Cyclone Land leg bracket installation for all models excluding 3413 <u>Description</u>

20v-521 & 2020-402

Big Horn Traveler, Elkridge, & Cyclone 3413 <u>Description</u>

RECALL SERVICE BULLETIN

Pictures below show bracket installed with shims in place and the bolts started holding the bracket in place.

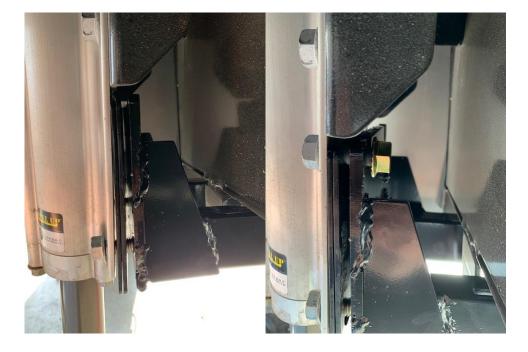
- 3. Use a floor jack with a piece of wood wide & long enough to support the bracket in the middle.
- 4. Lift bracket using floor jack into position between the front leveling jacks until the bottom set of holes on the bracket are lined up with the bottom set of holes on the jack leg.

- 5. Use the provided shims that are 1/8" & 1/4" thick to ensure that the bracket has no more than a ½" gap to be closed up when tightening bolts. (Some brackets may not require any shims & will have less than ½" gap once in place)
- 6. Once the bracket holes are lined up use a ¾" impact socket and driver to start the stainless steel self-tapping bolts in the bottom two holes. Insert the matte silver bolts into the top holes and use a ¾" impact socket and driver on the bolt and a ¾" wrench to hold the nut on the back while tightening. Only snug up bolts until all bolts have been installed in the bracket.

- 7. Once you have all the bolts on both sides of the bracket snug all bolts down until tightened.
- 8. Using a torque wrench, torque all the bolts to 65 ft. lbs.
- 9. Lower the front landing legs back down and remove the tripod and wheel chock

Pictures below show bracket installed with shims in place and the bolts started holding the bracket in place.

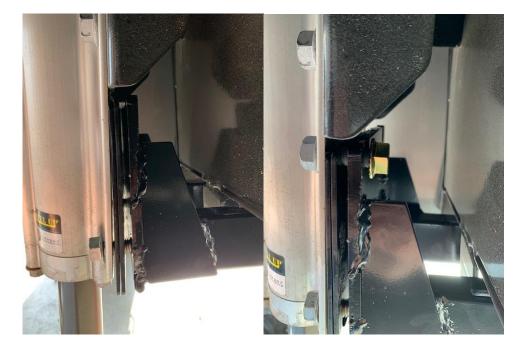
- 12. Use a floor jack with a piece of wood wide & long enough to support the bracket in the middle.
- 13. The jack brackets bottom set of holes need to be lined up with the bottom set of holes in the jack leg. The front landing legs may need to be uninstalled and lowered 1-2 sets of bolt holes so the bracket will be able to be installed correctly. Use a ¾" impact socket and driver with a ¾" wrench to loosen and remove the bolts from the jack. There should be three sets of bolt holes available once the bracket has been reinstalled correctly. The jack bolts may need to remain loosened until the bracket is in place and then all bolts can be tightened down. All bolts need to be torqued to 65ft. lbs.

- 15. Use the provided shims that are 1/8'' & 1/4'' thick to ensure that the bracket has no more than a $\frac{1}{2}''$ gap to be closed up when tightening bolts. (Some brackets may not require any shims & will have less than $\frac{1}{2}''$ gap once in place)
- 16. Once the bracket holes are lined up use a ¾" impact socket and driver to start the stainless steel self-tapping bolts in the bottom two holes. Insert the matte silver bolts into the top holes and use a ¾" impact socket and driver on the bolt and a ¾" wrench to hold the nut on the back while tightening. Only snug up bolts until all bolts have been installed in the bracket.

- 17. Once you have all the bolts on both sides of the bracket snug all bolts down until tightened.
- 18. Using a torque wrench, torque all the bolts to 65 ft. lbs.
- 19. Lower the front landing legs back down and remove the tripod and wheel chock
